Response to Key Issues
Preferred Project Report
Revised Statement of Commitments

**STAGE 1 PROJECT APPLICATION
(MP 09_0219)**

FOR HOLDMARK PROPERTY GROUP PTY LTD
JULY 2012

SHEPHERDS BAY URBAN RENEWAL, MEADOWBANK

FIGURE 9. STAGE 1 DEEP SOIL PLANTING PLAN

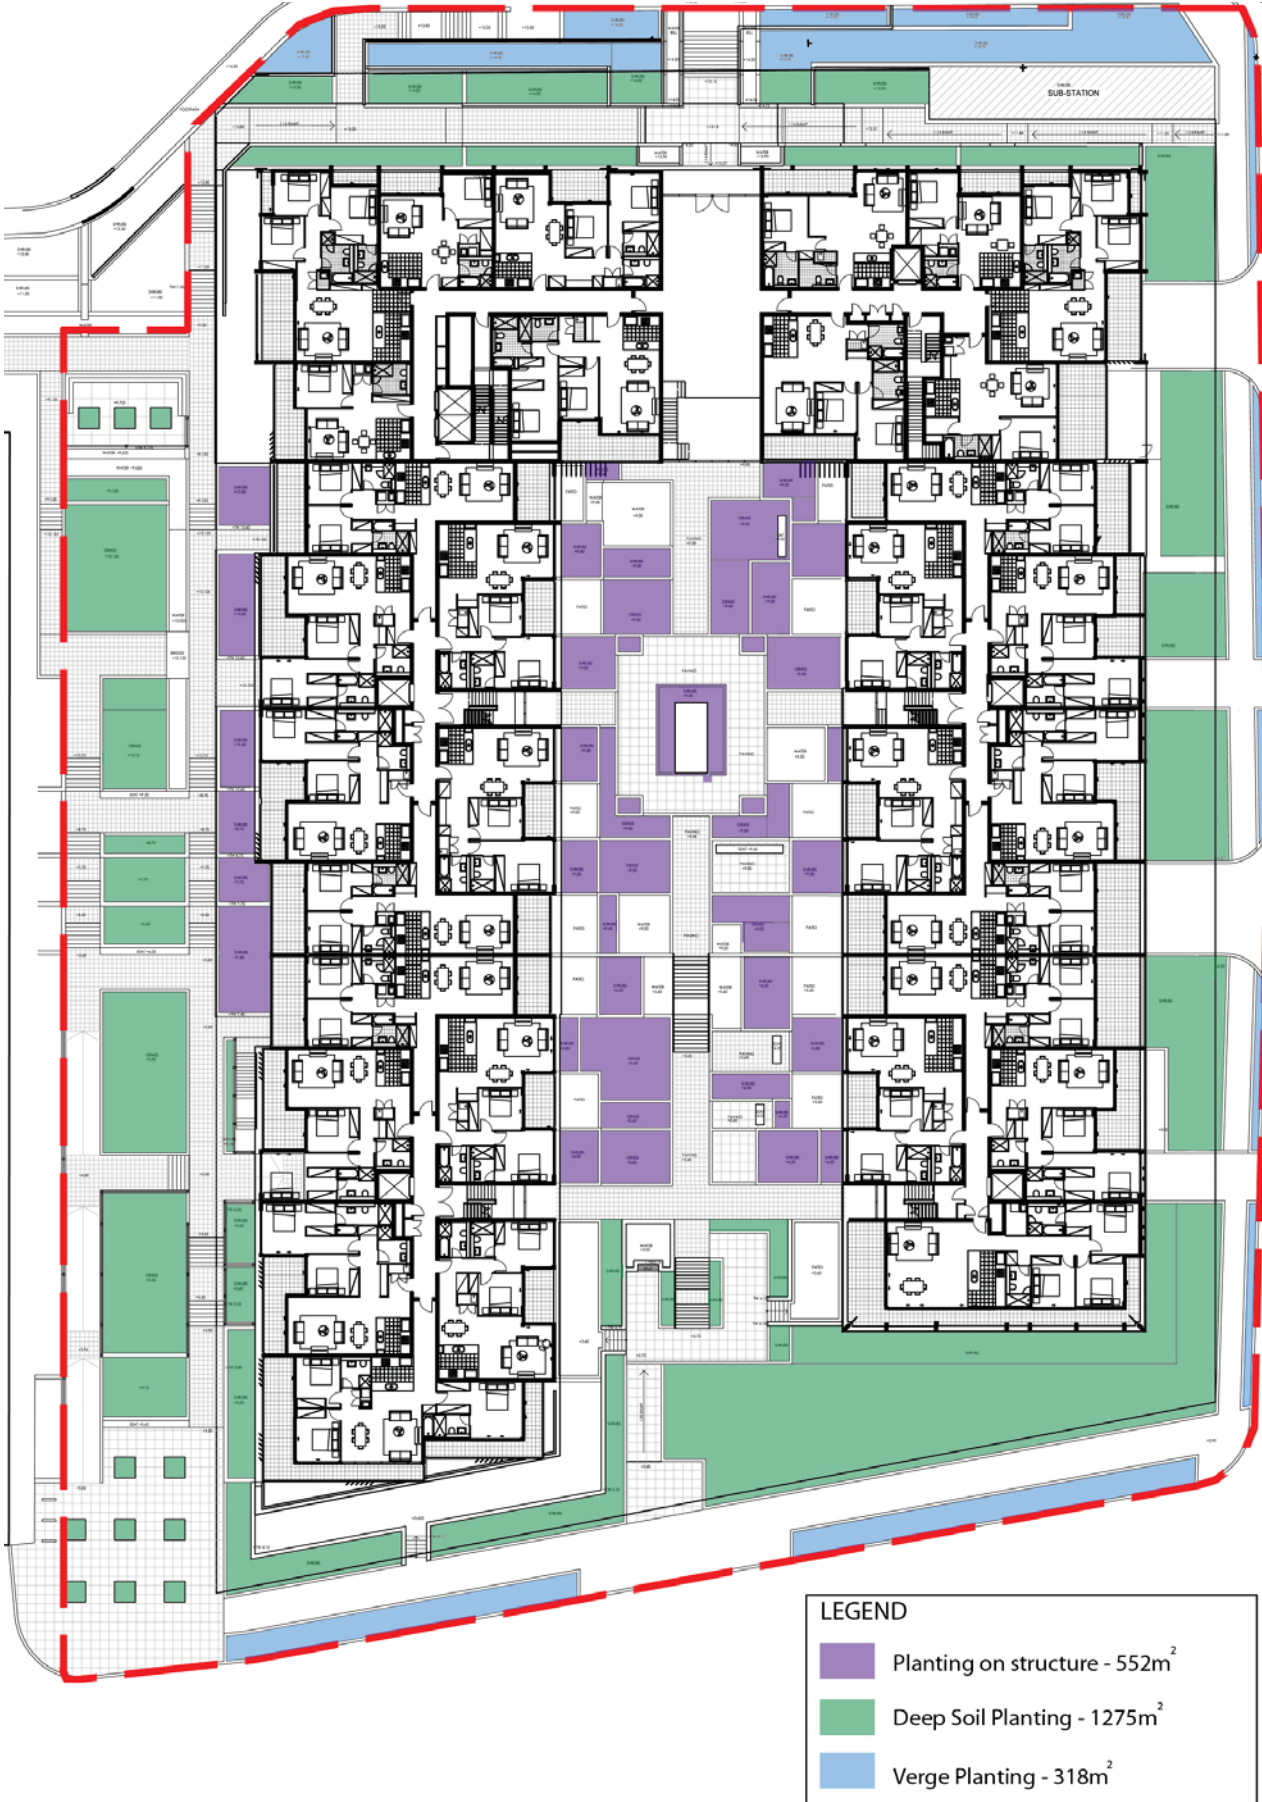
PUBLIC OPEN SPACES - DEEP SOIL PLANTING AREAS

Proponent response:
As detailed in the submitted Concept Plan PPR, it is important to note that 1,495sqm of the Stage 1 Project site is provided as deep soil planting with a further deep soil over podium area of 662sqm being provided which together equal more than the 25% SEPP65 guideline. This is considered appropriate in view of the Council DCP and Concept Plan requirement for a through site paved publicly accessible pedestrian link to the foreshore reserve to be provided on site and the site's location adjacent to that large public open space area
